Title		
Billionton Systems Inc.		
Size	Document Number	Rev
Custom	Bluetooth V90 Modem DAA Line	1.0
Date:	星期二 十二月 02, 2003	Sheet 1 of 5

Title			
Billionton Systems Inc.			
Size	Document Number	Rev	
Custom	Bluetooth V90 Modem power	0.1	
Date:	星期二, 十二月 02, 2003	Sheet	3 of 5
	2	1

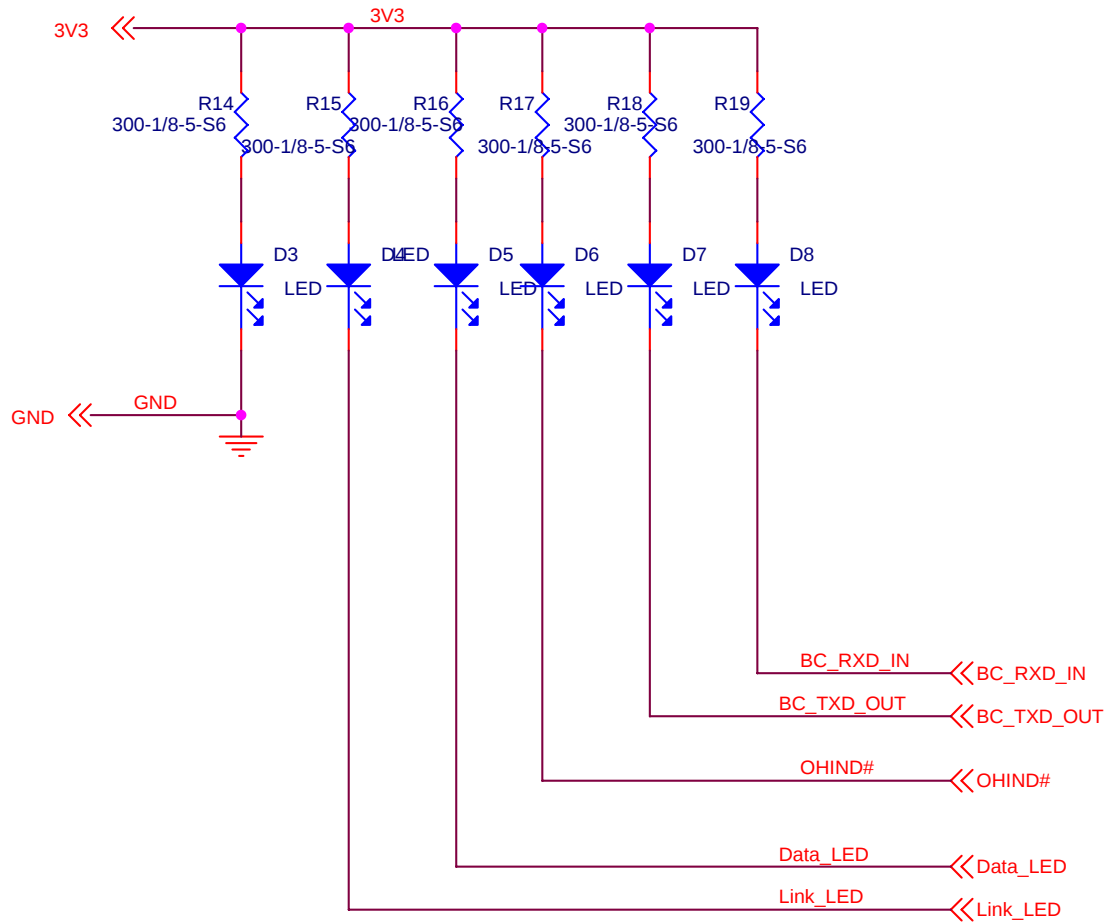
Add AGND_LSD in this DAA side in 3 Layer
Keep 3mm uper space

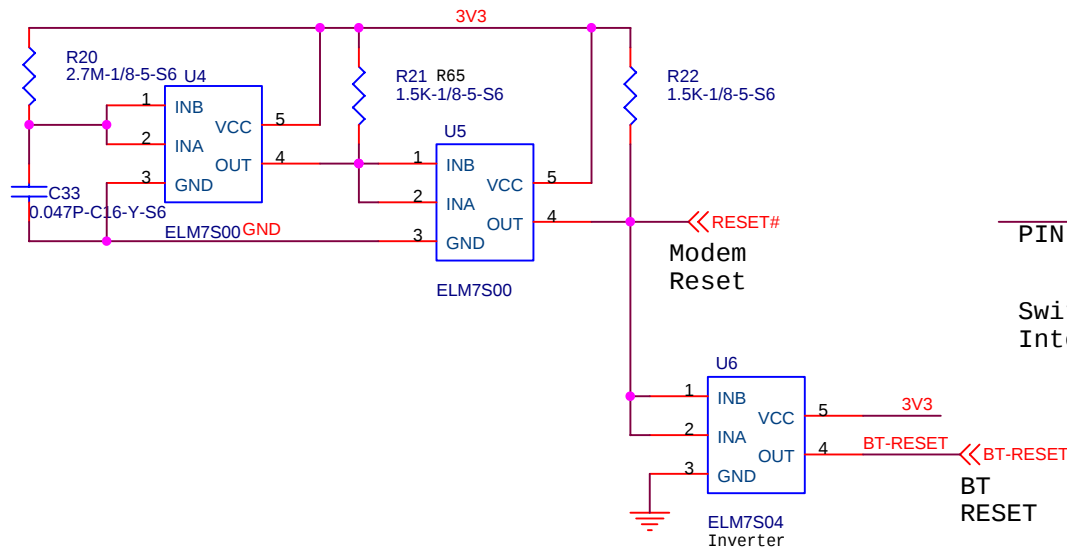
Change the LD0 to MIC2920-3.3BS ,Package is SOT223
